Service Bulletin No. 35

SUBJECT: Upper aileron cable interference with rub block and wing skin where the cable exits the wing skin.

AIRPLANES AFFECTED: All Maule airplanes.

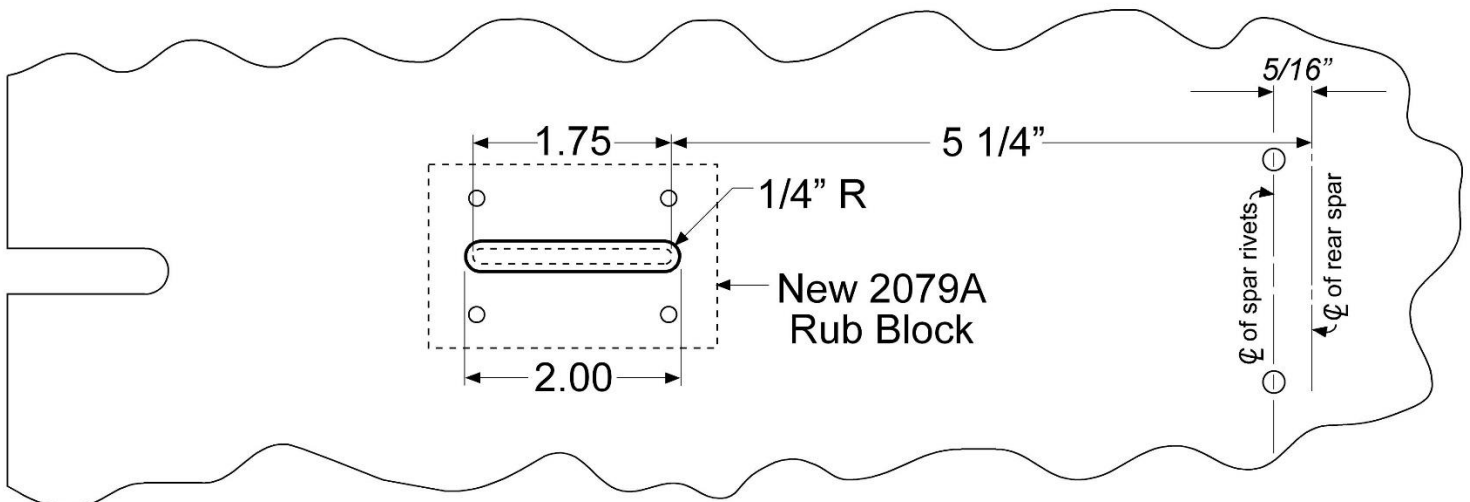
BACKGROUND: Recently during an FAA product audit on a completed aircraft, it was discovered that the aileron cable where it exits the top wing skin had no clearance on the rub block and wing skin at full deflection. Inspection of other aircraft that were available for inspection revealed minimal clearance on these other aircraft. Maule has received no field reports of this issue but feel that in the interest of safety it should be addressed on all Maule aircraft.

ACTION TO BE TAKEN: Before further flight inspect aileron cables at full deflection where they exit the top wing skin for any interference and/or cable wear. If sufficient clearance exists and there is no sign of cable wear or fraying, no further action is necessary. If interference is found but there is no cable wear or fraying this will require the rub block replacement portion of this action only. If interference is found and there are signs of wear or fraying of the aileron cable, this will require aileron cable and rub block replacement. There is a new aileron cable rub block available (P/N 2079A) with a $\frac{1}{2}$ " longer opening. This will require routing or filing the wing skin slot $\frac{1}{2}$ " ($\frac{1}{4}$ " at both ends) in accordance with the illustration #1 shown below.
